SUBJECT: NUREG-0737 Item II.F.1.4 Containment Pressure Monitor  
Item II.F.1.5 Containment Water Level Monitor  
Item II.F.1.6 Containment Hydrogen Monitor

RE: Peach Bottom Atomic Power Station

SUBJECT: Request for Additional Information  
NUREG-0737. Items II.F.1.4, 5 and 6  
Peach Bottom Atomic Power Station Units 2 and 3

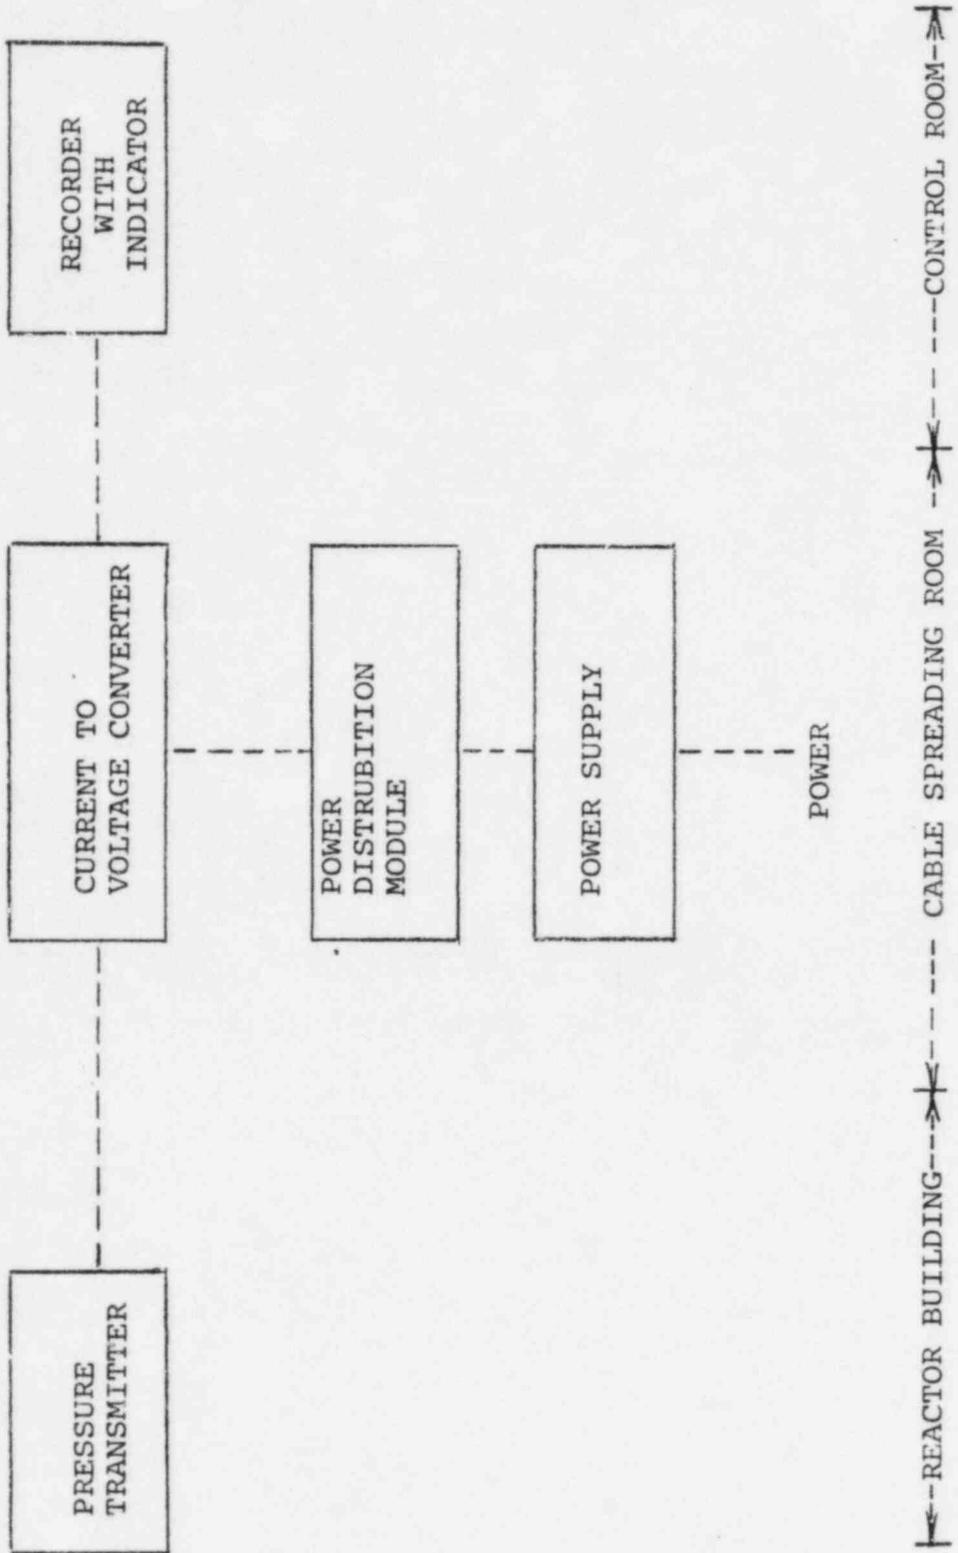
(4d) Indicate the placement and number of hydrogen monitor intake ports in containment. Indicate any special sampling techniques that are used either to examine one region of containment or to assure that a good cross section of containment is being monitored.

(4d) Redundant analyzers are provided to monitor hydrogen concentration in each drywell and torus. Samples are withdrawn through primary containment penetrations at the following elevations:

drywell: El. 127'-2"  
drywell: El. 199'-9"  
torus: El. 125'-0"  
torus: El. 114'-0"

Since the primary containment is not compartmentalized, except into drywell and torus, multiple sample points within the containment compartments for each analyzer are not considered necessary. An analysis of the effectiveness of combustible gas mixing within the PBAPS primary containment is included in FSAR Supplement 1, Response to Question 14.6.

FIGURE 1

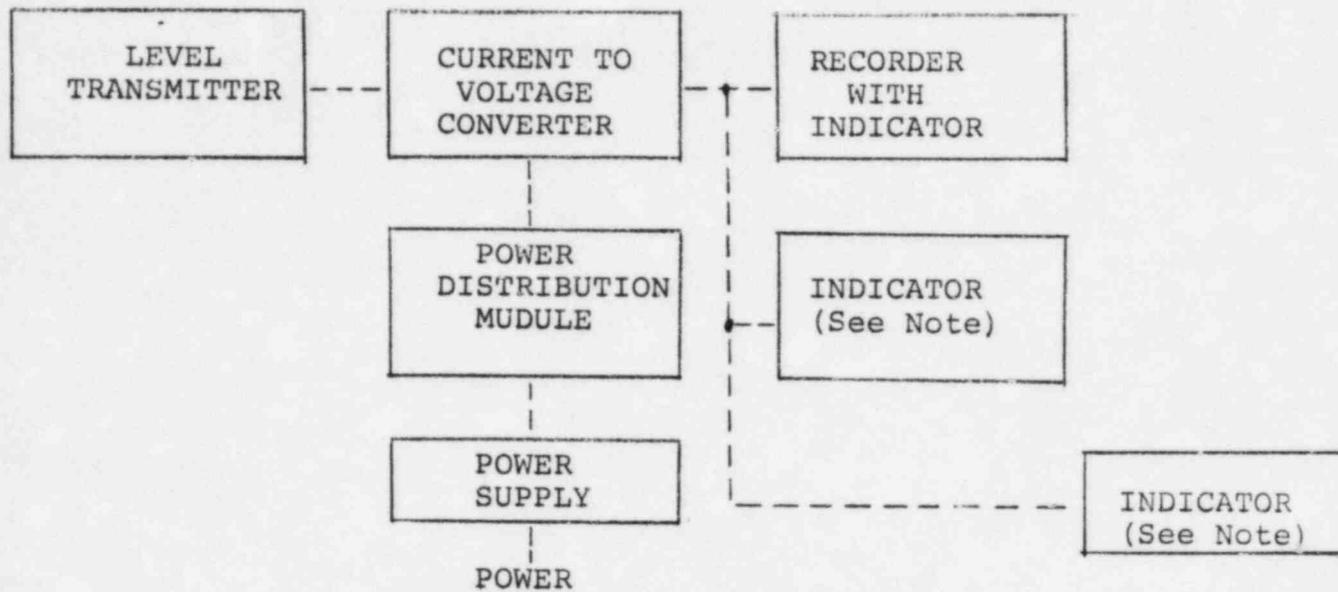
- (2a) Provide a block diagram of the configuration of modules that make up your PMS. Provide an explanation of any details in the block diagram that might be necessary for an understanding of your PMS accuracy and time response.

- (2a) See figure 1 for a block diagram of the configuration of modules that make up the containment pressure monitoring system. There are four instrument loops, two with a range of 0 to 225 psig and two with a range of 5 to 25 psia. The power for the instrument loops and the power to run the recorders is provided from the power supply through the power distribution module.
